Department of Energy

01-DOE-00756

We are in receipt of your letter of March 2, 2001, on the results presented on the Solar Ponds Plume Treatment System that were presented in the Quarterly Report for the Rocky Flats Groundwater Plume Treatment Systems, October through December 2000, and are providing the following responses. These responses are based on information provided earlier through other, less formal communications about this issue.

Enclosure 1 – Solar Ponds Plume System Decision Tree

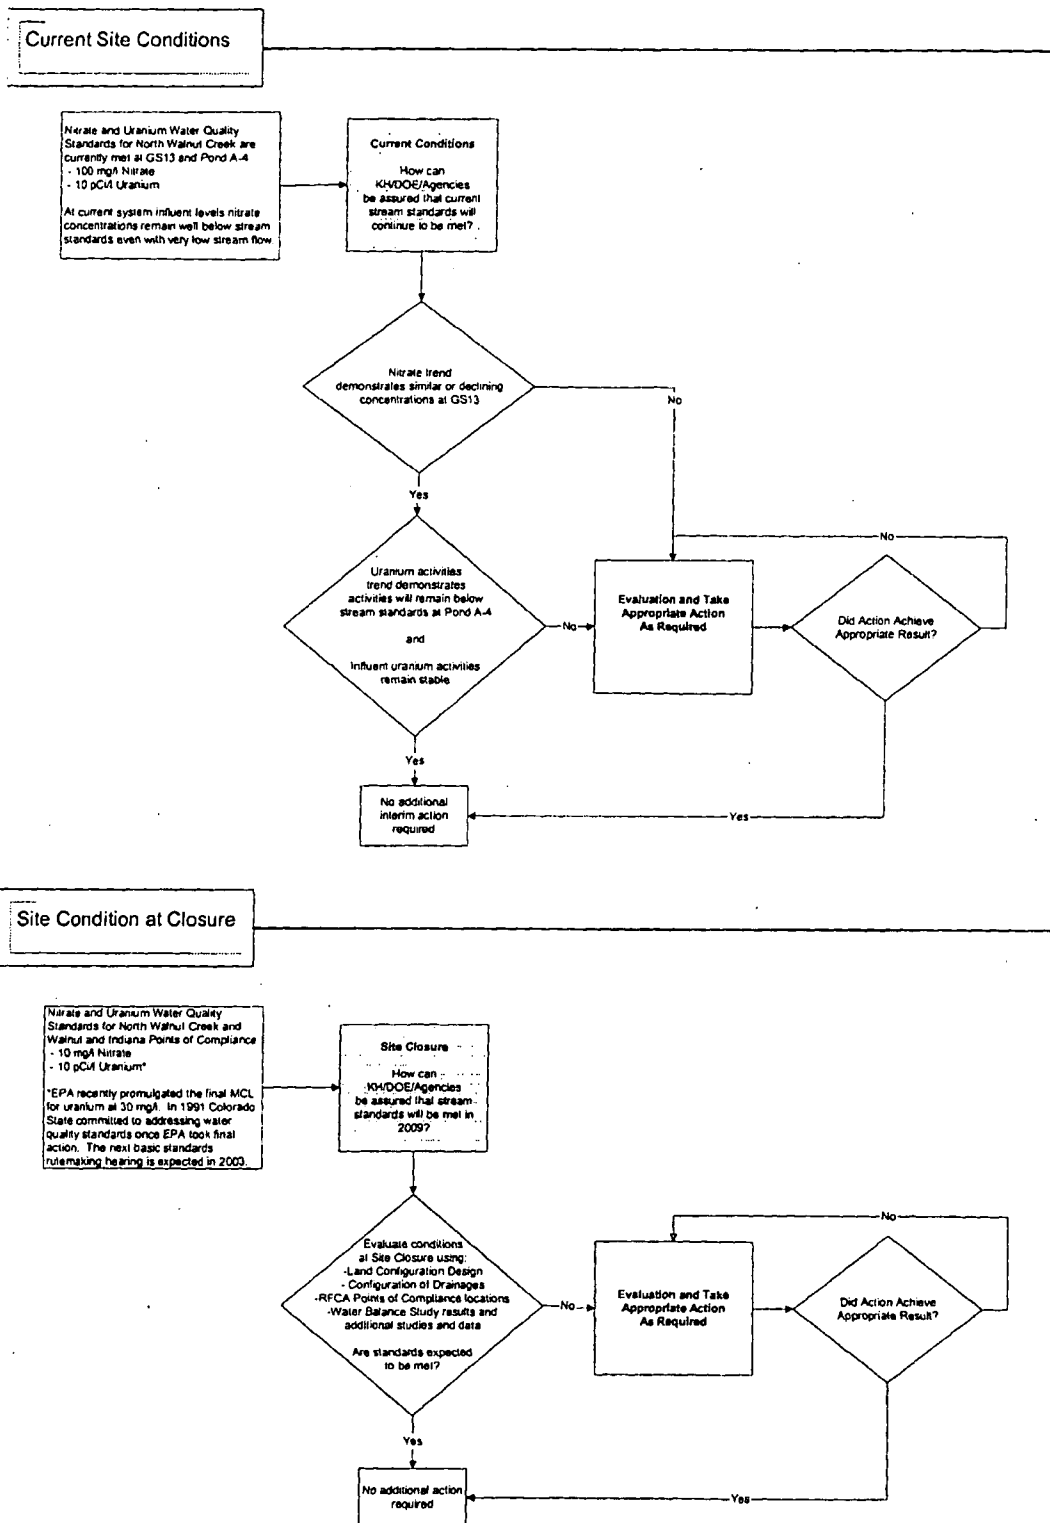
There is not a long period of time between now and the projected site closure of 2006 in which to collect data to evaluate these problems. The State and EPA will not be willing to sign off on a CAD/ROD for Rocky Flats if there is still a high level of uncertainty as to whether the underlying standard for nitrates will be met once the temporary modification expires (currently in 2009). There are also uncertainties relative to when the uranium ground water plume will peak at the collection system and at what concentration. There are questions concerning the long-term stewardship ramifications of having an imperfect treatment system in place for these plumes. As you know, we are working to define some important cleanup and closure decisions in the RFCA Integrated Decision Document, tentatively scheduled in the 2002-2003 timeframe. The agencies will want the solar ponds treatment system addressed as part of the framework in that decision document. The site will also have to discuss the status of meeting the underlying standard for nitrates at the next Water Quality Control Commission South Platte Triennial Review in 2003.

Given these arguments, the agencies contend that the Site needs to develop a more substantive and definitive schedule and timeframe for actions that might be appropriate to address the ability of the solar ponds plume treatment system to meet the underlying standard for nitrates, and to reduce uncertainty that the uranium surface water standard will be met in the future. We suggest that the technical aspects of such a schedule could be discussed in the Water Working Group.

The DOE is committed to meet stream standards at closure when the temporary modification for nitrate no longer applies. For that reason, a decision tree was developed to evaluate present conditions and decision points to determine if and when an action may be required to meet current standards. The decision process includes evaluating uranium concentrations at the influent location to determine whether an action is required based on increasing uranium concentrations. In addition, the future conditions are being evaluated to determine if an action is required to meet the applicable standards at Site Closure.

However, as the final end state of the Site will be determined over the next few years with input from stakeholders, the final Site Conditions cannot currently be evaluated. Therefore, the decision tree shows the process that will be used over the next few years to continually evaluate the impact at Site Closure from the Solar Ponds Plume to determine if additional actions will be required. Since this letter was received, the decision tree was briefed to both the EPA and the Colorado Department of Public Health and Environment and is provided on Enclosure 1.

As stated in the previous comment response, the decision tree was developed to exhibit the conditions that would require an action to be taken. A separate decision process is in place to evaluate the impact at Site Closure from the Solar Ponds Plume to determine if additional actions will be required.
